#### **Federal Motor Vehicle Safety Standards; Seat Belt Assemblies**

**ACTION:** Final rule.

**SUMMARY:** This final rule amends the Federal motor vehicle safety standard (FMVSS) for seat belt assemblies to redefine the requirements and to establish a new test methodology for emergency-locking retractors. Specifically, this final rule establishes a new acceleration-time corridor, adds a figure illustrating the new acceleration-time corridor, provides a tolerance on angle measurements, and adopts the same instrumentation specifications currently found in other FMVSSs containing crash tests.

Figure 8: Acceleration Corridors

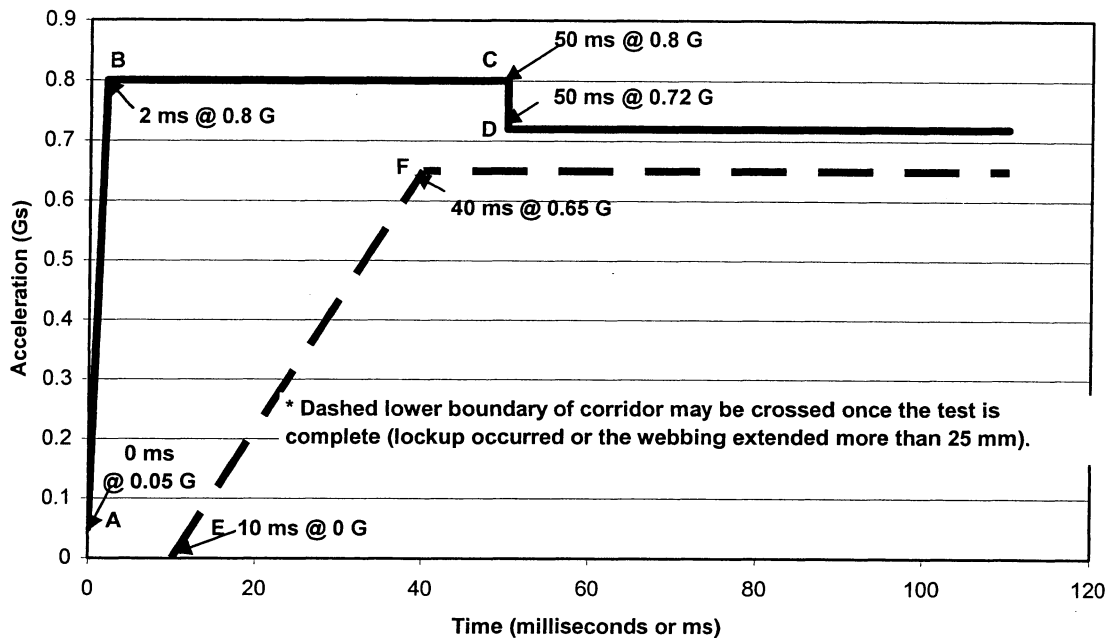
- The final rule modifies that portion of FMVSS No. 209's test procedures relevant to ELRs by adopting a new Figure 8 which provides a specified acceleration-time corridor for test pulses. The A–T corridor includes an upper boundary onset rate of 375 g/sec and permits acceleration to peak at up to 0.8 g. The lower boundary of the A–T corridor allows for a minimum onset rate of 21.67 g/sec. The steady-state tolerance range is from 0.65 g to 0.72 g.

In response to these comments, the agency has decided to modify the lower boundary of the A-T corridor in the manner suggested by the AORC in its latest submission. NHTSA's intention in proposing the lower boundary in the NPRM was to ensure that it encompassed current test pulses, particularly those with slower onset rates. Although the AORC did not provide any data to demonstrate the nature and extent of this "nuisance locking" problem, we believe that the AORC's proposed new lower boundary would address the concern of potential "nuisance locking," while maintaining inclusion of all current test pulses. In addition, we believe that the new lower A-T corridor should minimize the variation in onset rates, while maintaining the repeatability and reproducibility of the test procedures.

The agency notes that in this final rule, we have modified the lower boundary of the A-T corridor such that the initial peak must be obtained within 40 ms. However, we do not believe that this modification will impact any existing compliant ELR because agency data show that current acceleration pulses reach 0.7 g well before 40 ms.

of  $\pm 10$  g and processed according to the practices set forth in SAE Recommended Practice J211-1 rev. December 2003, "Instrumentation for Impact Test—Part 1—Electronic Instrumentation," Channel Frequency Class 60. The webbing shall be positioned at 75 percent extension, and the displacement shall be measured using a displacement transducer. For tests specified in S5.2(j)(2)(iii)(A) and (B), the 0.7 g acceleration pulse shall be within the acceleration-time corridor shown in Figure 8 of this standard.

Reference Point	Time (ms)	Acceleration (g)
A	0	0.05
B	2	0.8
C	50	0.8
D	50	0.72
E	10	0
F	40	0.65
